Laguna Madre Water District
Wastewater Treatment Plants Rehabilitation
 September 2016

Isla Blanca WWTP
Site Plan And
Mechanical Modifications
To Existing Plant

Laguna Madre Water District
 Andy Bowie Wastewater Plant
 Chlorination & Dechlorination Equipment

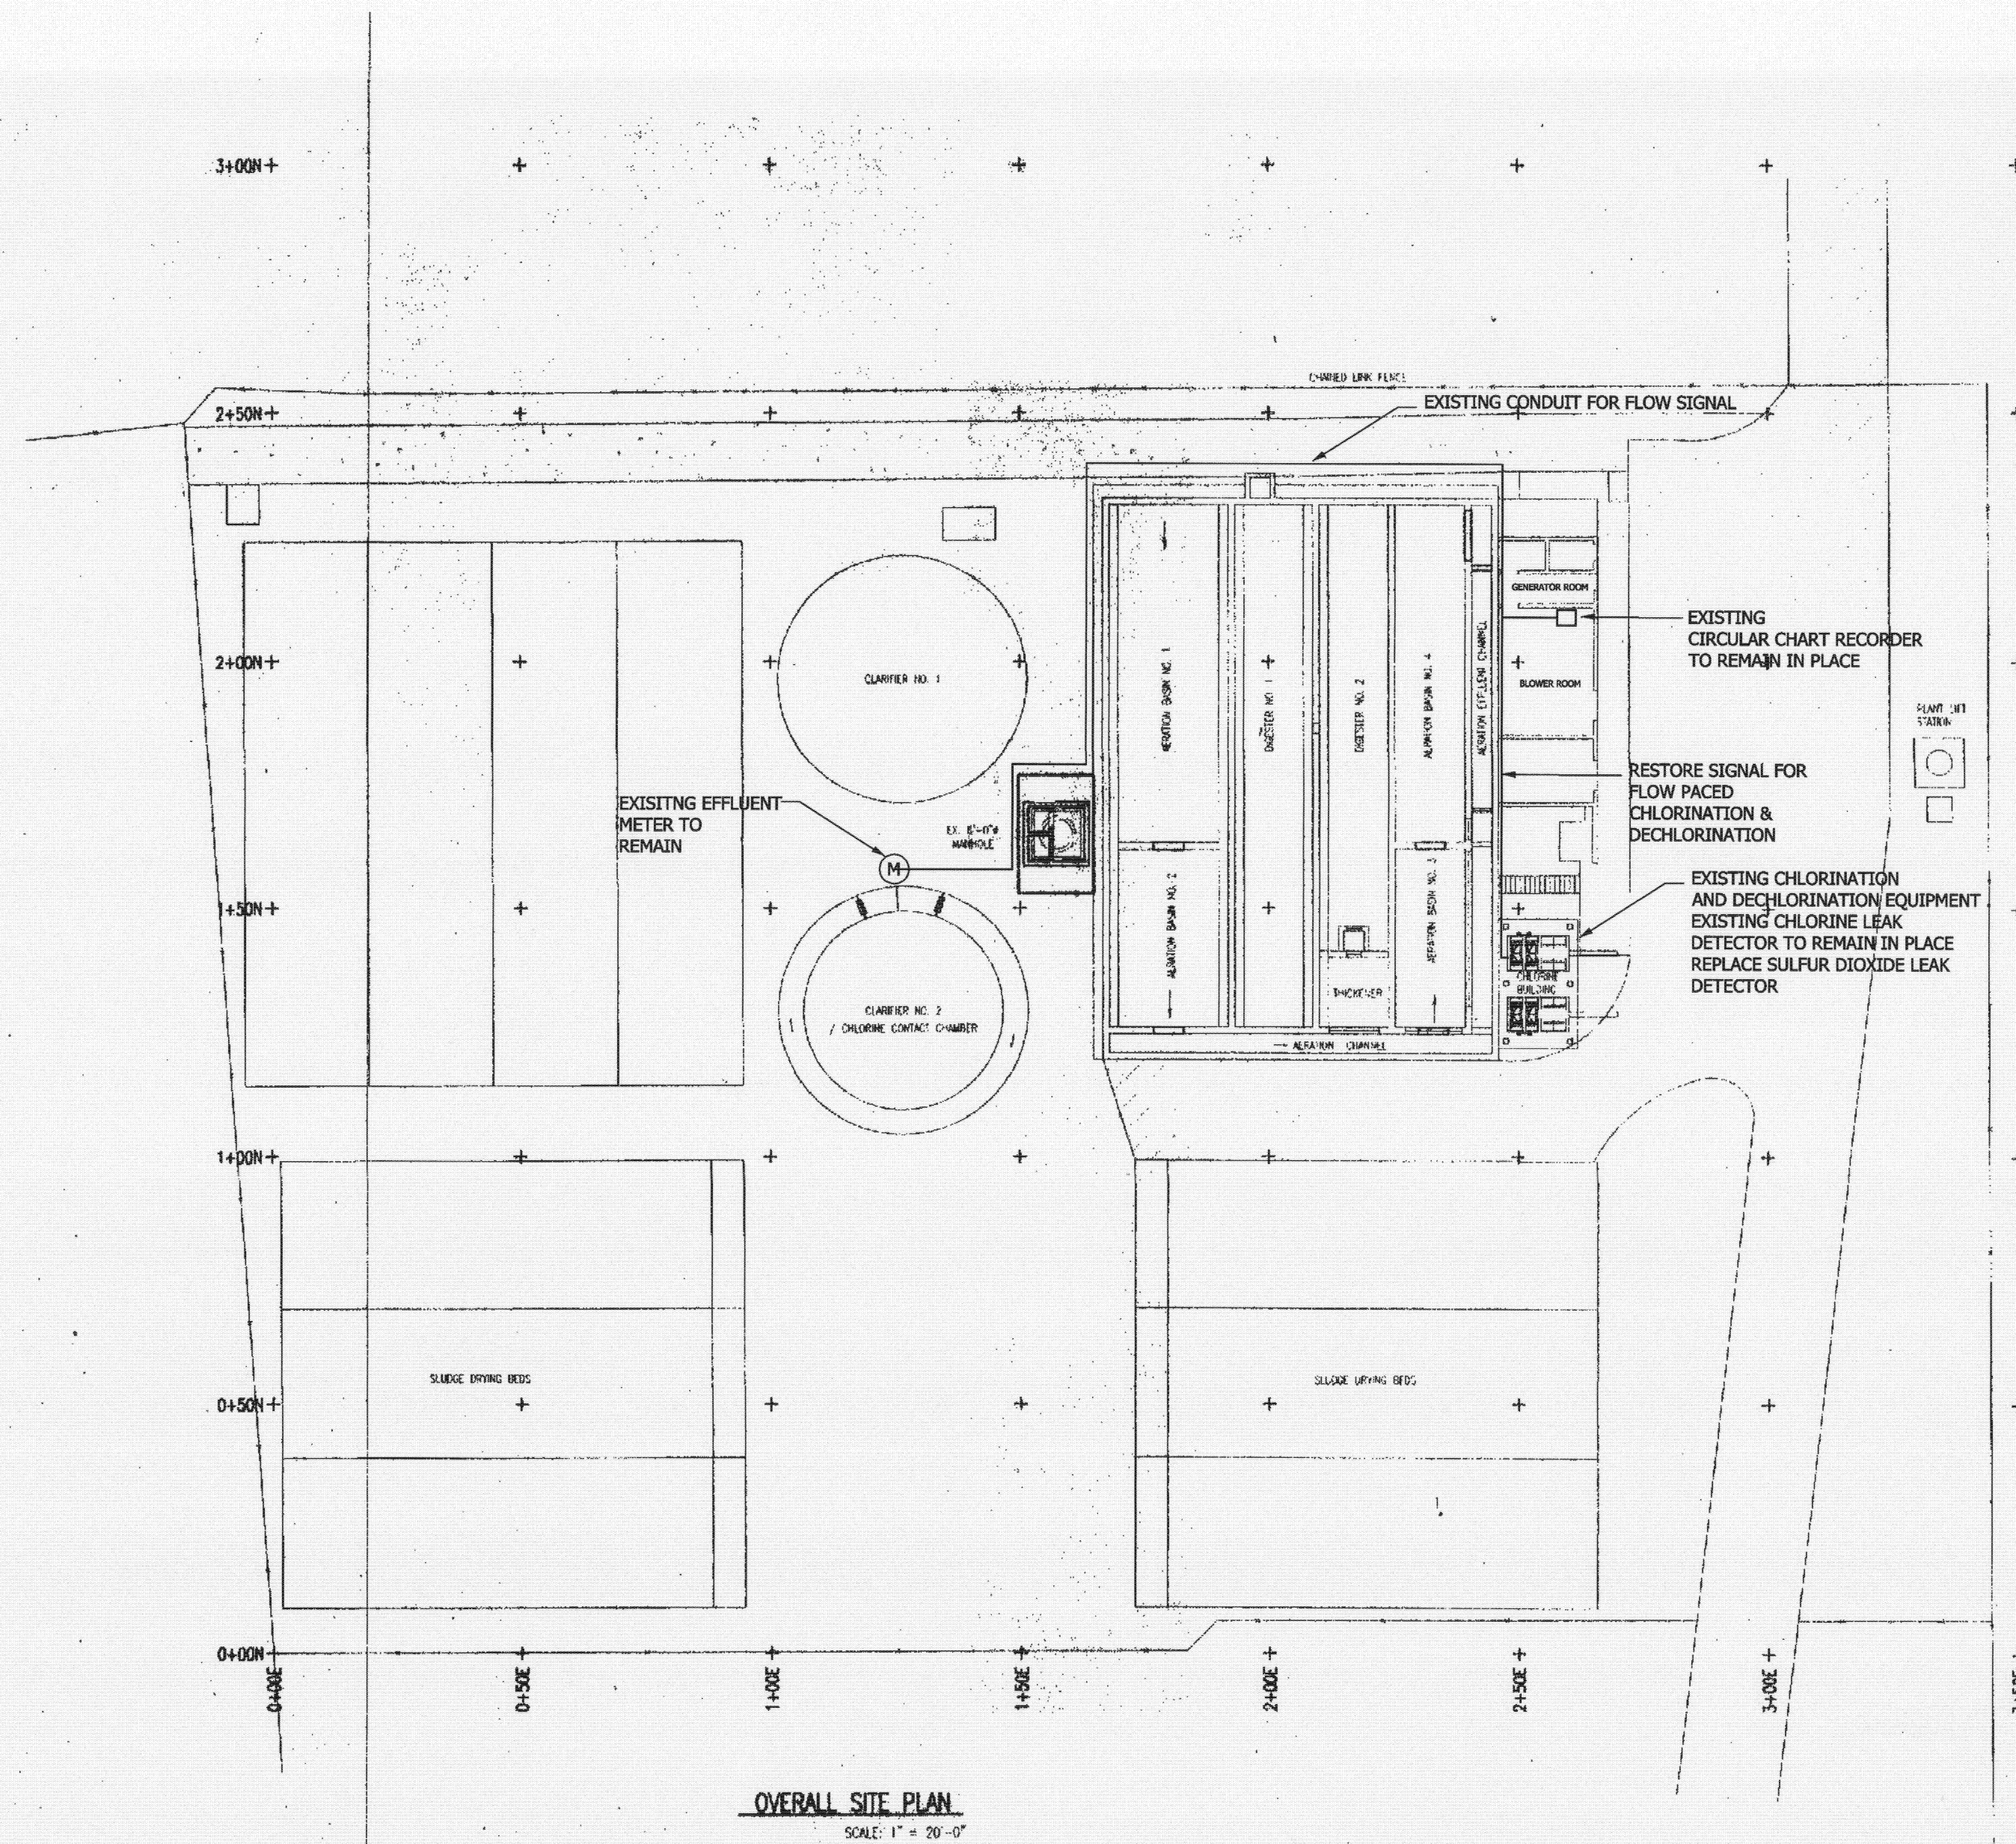
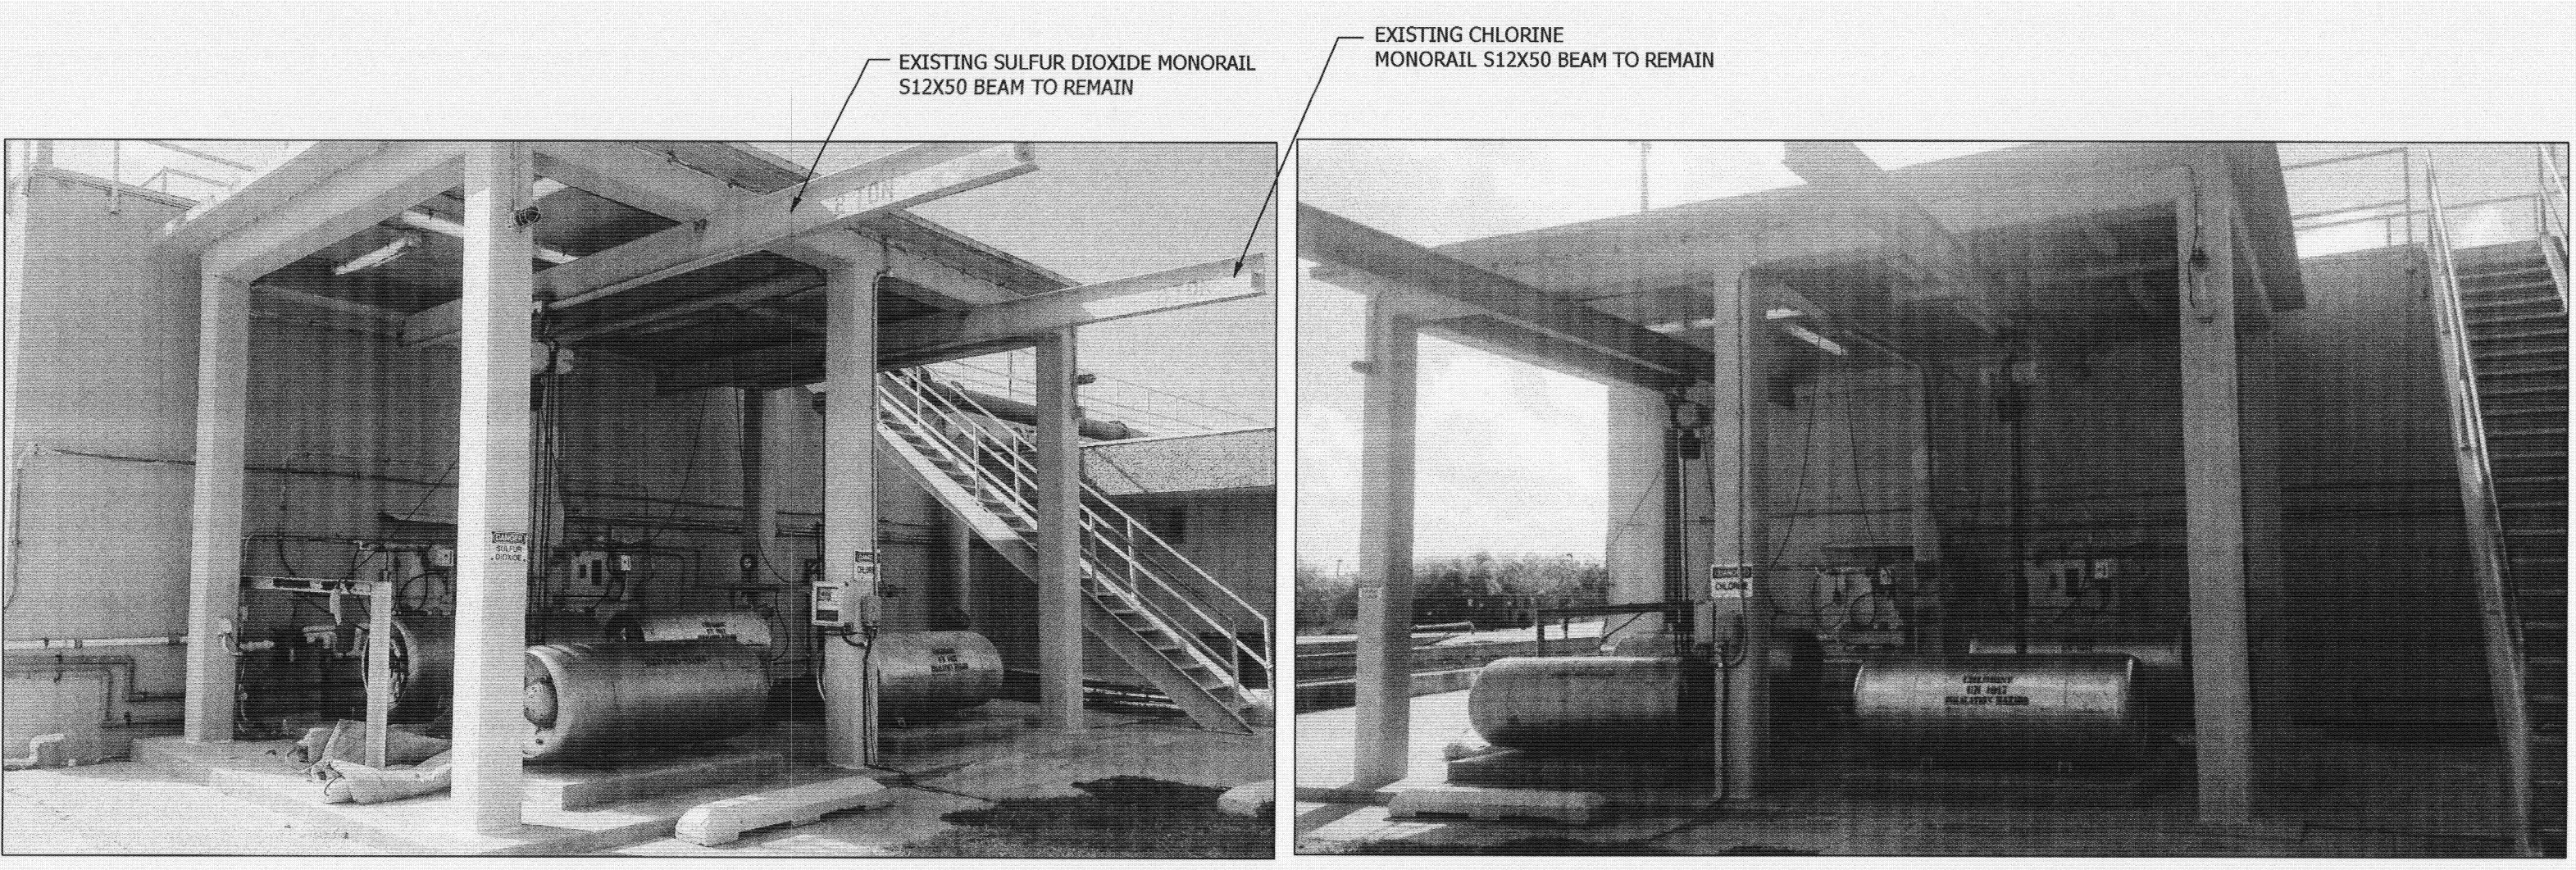
NOTES:
 ADDENDUM No1: SIZE ALL PROPOSED ROTAMETERS FOR 250 PPD. DISTRICT DOES NOT USE INDUCTION PUMPS FOR CHLORINATION AND DECHLORINATION EQUIPMENT. EXISTING VENTURI SYSTEM TO REMAIN IN PLACE. AUTOMATIC SWITCHOVER REMOVED FROM ALL VACUUM REGULATORS. RESTORE EJECTORS AT ALL SITES.

PROCESS FLOW SCHEMATIC

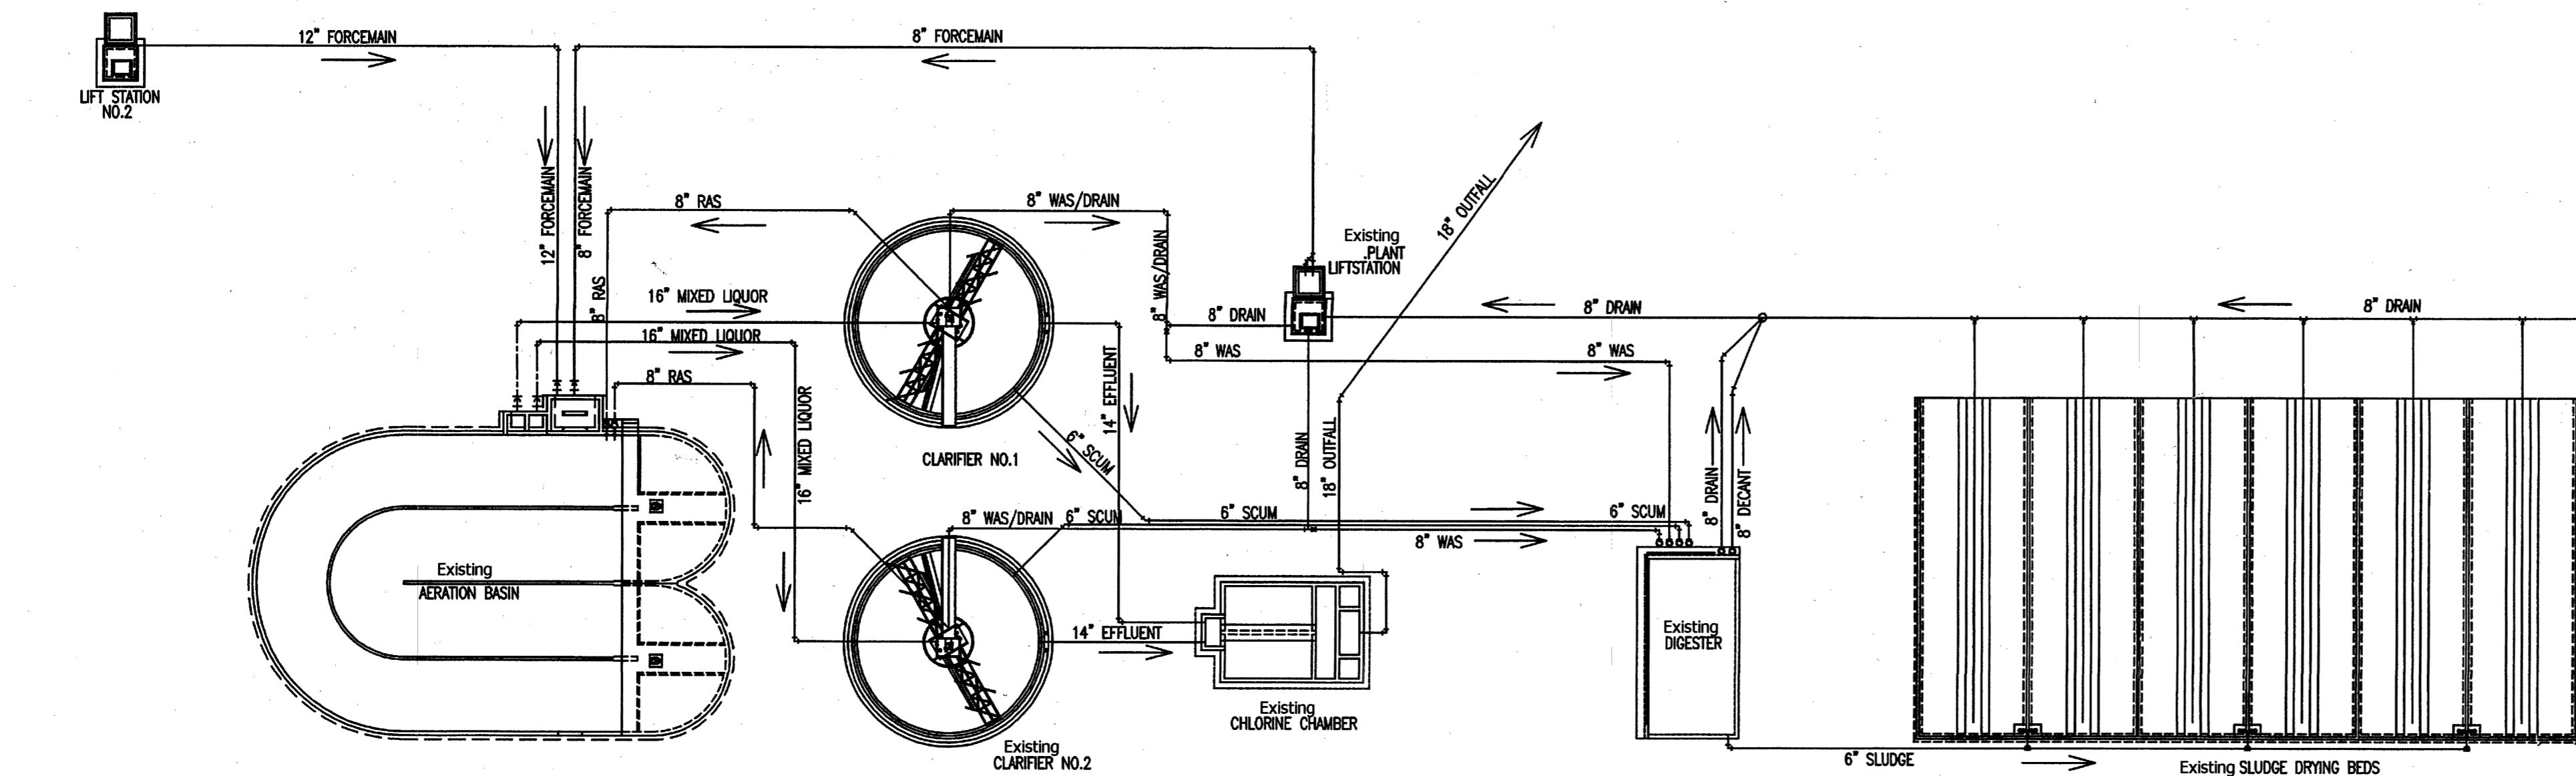
NOTES
ADDENDUM No. 1: CHANGED "PROPOSED" TO "EXISTING" AS NEEDED TO SHOW EXISTING CONDITIONS. REVISED PROPOSED HIGH SPEED TURBO BLOWER, MODEL No. TO NX30-C050 OR APPROVED EQUAL.
